PRODUCT/PROCESS CHANGE NOTICE (PCN)

PCN #: TB-0609-02	DATE: 06-Oct-2006	MEANS OF DISTINGUISHING CHANGED DEVICES:
Product Affected: SOJ 28L, 32L, 36L Products		<input type="checkbox"/> Product Mark
shipped in tube		<input type="checkbox"/> Back Mark
Date Effective: 06-Jan-2007		<input type="checkbox"/> Date Code
		<input checked="" type="checkbox"/> Other
		Rev. 08 printed on shipping tube

ATTACHMENT I - PCN #: TB-0609-02

TOLERANCES UNLESS OTHERWISE SPECIFIED		DECIMALS		ANGLE	
.X	±.25	.XX	±.13	.XXX	±.13
APPROVALS		DATE		SCALE	
DRAWN		TITLE:		N/A	
CHECKED		PB/PBG 28/32/36		SIZE	
		SHIPPING TUBE		B	
		STOCK NO.		REV	
		P1-069-000 MSC-3026		14	
DO NOT SCALE DRAWING		SHEET 1 OF 1

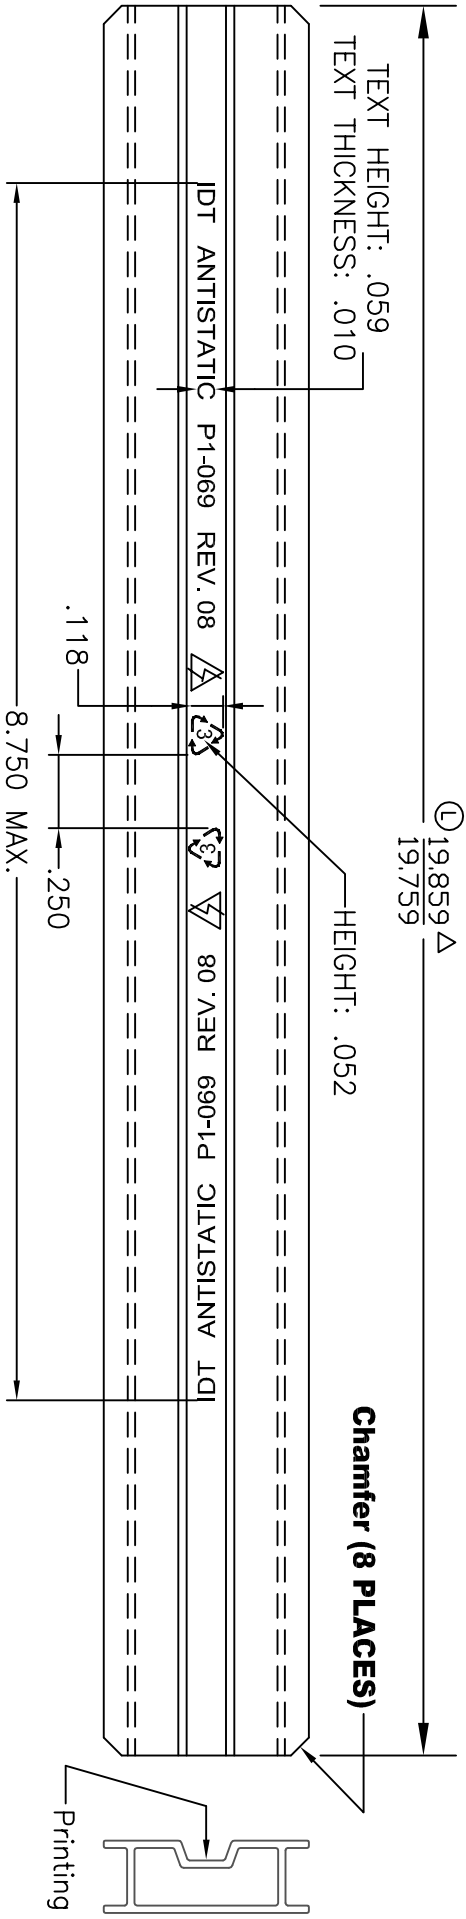
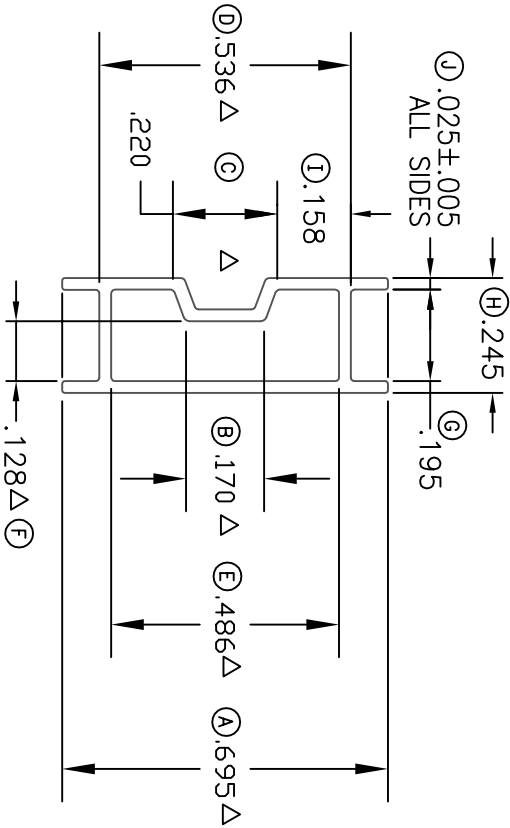
** Note: Tube opening height is denoted as dimension 'F' in the tube drawing. See attachment for the drawing.*

REVISIONS				
REV	DESCRIPTION	DATE	APPROVED	
13	INCLUDED ITW MERITEX AS SUPPLIER	03/11/06	KK Thee	
14	INCREASE (F) FROM 0.105" TO 0.128"	08/24/06	KK Thee

Detail of Change: This notification is to advise our customer that IDT has qualified new shipping tubes for SOJ 28L, 32L, 36L products. The new shipping tubes have an increase in the tube opening height from 0.105 inches to 0.128 inches to provide better protection for packages during assembly, test and backend processes.
